Service Engineering Operations
Customer Service Division

TO: All U.S. Ford and Lincoln Dealers
SUBJECT: **Special Field Action 25L05**
Certain 2024-2025 Model Year F-150 Vehicles Equipped with 2.7L Engine
Vehicle Emission Control Information (VECI) Label Update

FIGURE 3

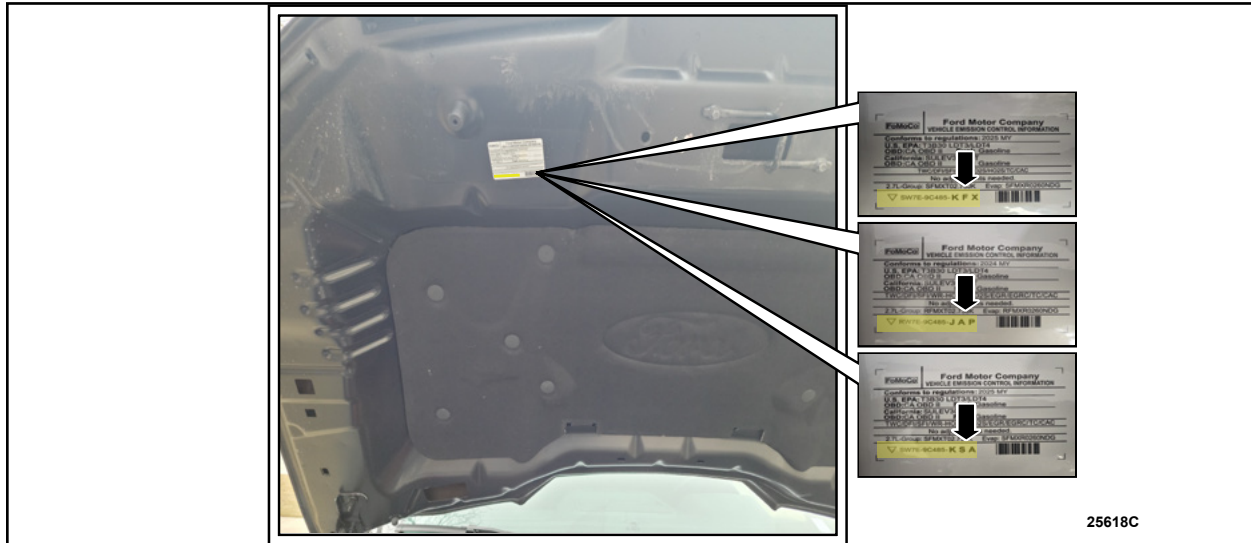
6. Inspect the old VECI label on the inside of the hood and locate the part number. See Figure 3.

7. Does the part number on the old label, match the part number on the *new* label?

No - Speak to the Service manager and retrieve the correct VECI label for placement.
Proceed to Step 8.

FIGURE 4

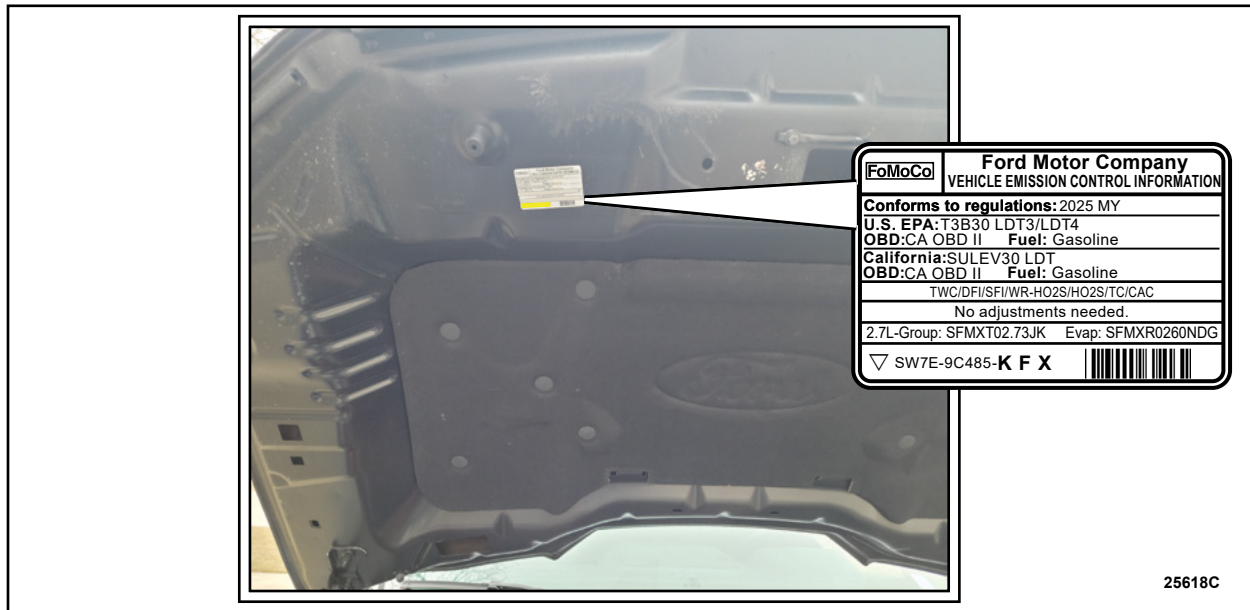
On the affected vehicles, the Vehicle Emission Control Information (VECI) label contains an incorrect description of an emissions control device.

10. Place the *new* VECI label, shown below, directly over the original label.

In-Stock Vehicles: Supplemental VECI labels with the correct information will be mailed to dealers with affected vehicles (to the attention of the Service Manager) the week of June 15, 2026. Dealers are to install a corrected VECI label directly over the existing VECI label on any affected vehicles in inventory, as instructed in the Technical Instructions attached.
